NWB2NA0305

9545-1-2-NAN-G

Re: Emergency Response/Spill Contingency Plan and Abandonment and Restoration Plan.

Indian and Northern Affairs Canada Spill Contingency Plan Review Checklist

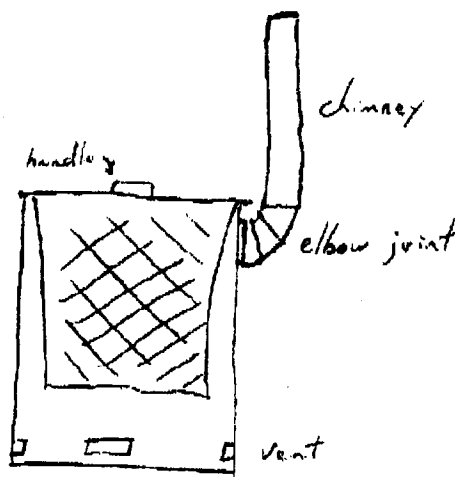
As per your request, here is an update on our incinerator plans: Due to a mis-communication between the welding company and myself, the exact plans you received from me were not constructed. It was reasonably close though. The most important part of the design is still that the lid and wire mesh basket are a one piece unit. This accommodates easy use and portability. The lid however was not constructed as a split-hinged lid. It is a whole lid but still has the 6" hole for the stove pipe on top. The lid opens from the basket at a hinge located behind the 6" hole at the lip of the basket. Remember the lip keeps the unit on top of the drum. The lid now has stoppers which can hold it open at a 90° angle to the basket.

I tested out the unit on ordinary household garbage. It contained thick cardboard, newspaper, plastic, leftover fish parts, an oyster tin, and two aluminum pop cans (among other things). With three holes punched in the bottom of a 45-gallon drum and only using regular unleaded gas & wood for fuel, the burn went very well. An excellent draft was created and smoke poured out the chimney (6' of stove pipe was used). Few ashes were left after the burn. Nothing was left of the aluminum pop cans but the oyster tin and some tin-foil were left unscathed. I was quite pleased with the results however we still recommend a slower burning fuel for incineration.

There is a problem for our model however. The lid acts as a flue channelling the flow of smoke and heat to the chimney. If the lid is opened during incineration, it is likely that flames may shoot out at the body opening it. The operator will not be able to add garbage to the unit unless the burn is completed. This may pose a problem to the larger camps which create lots of garbage to burn at once. However if multiple incinerator units are in place at a camp, and burns are completed after every meal, the units should be able to withstand the garbage load created.

Andy [REDACTED] (Con. Ed. Officer, Yellowknife) likes the idea of moving the chimney to the side of the drum. Using an elbow joint affixed to the side, the stove pipe would protrude from there. The lid and basket would still be a one piece unit. Andy is now working on getting that model made up and sent out. This model would be safer as the flue is on the side of the barrel, not the top. However, the problem with this is that assembly is required for use. In the field, someone will have to punch a hole in the side of the drum and then bolt the elbow joint to it. I believe the best model should require little or no assembly or maintenance.

side view

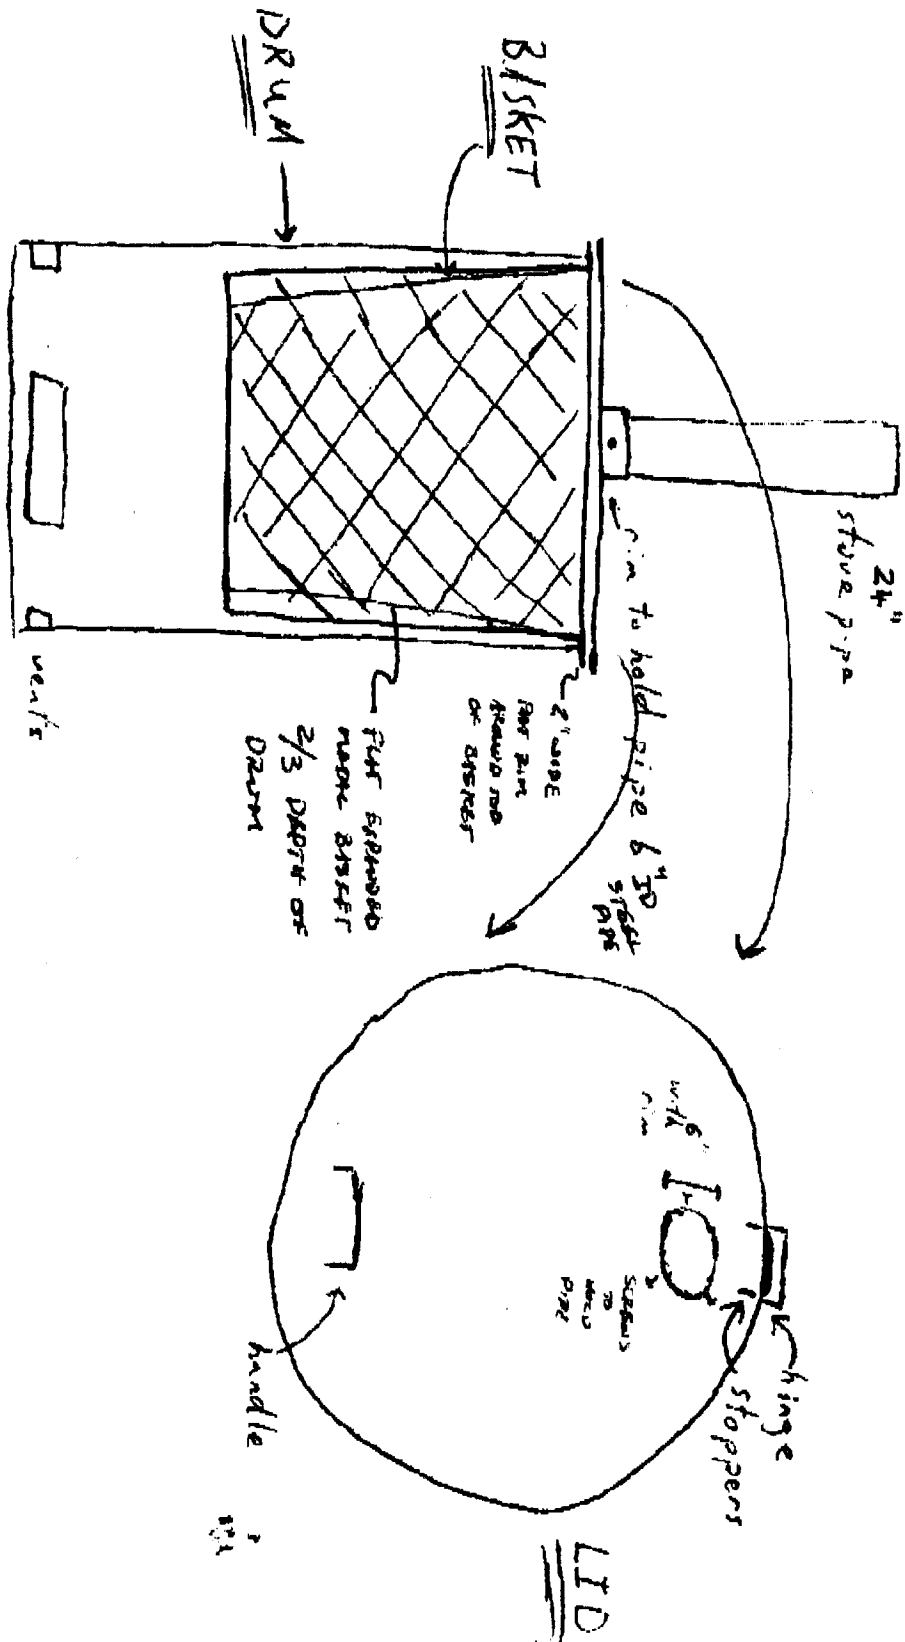
Basket Material was expanded metal
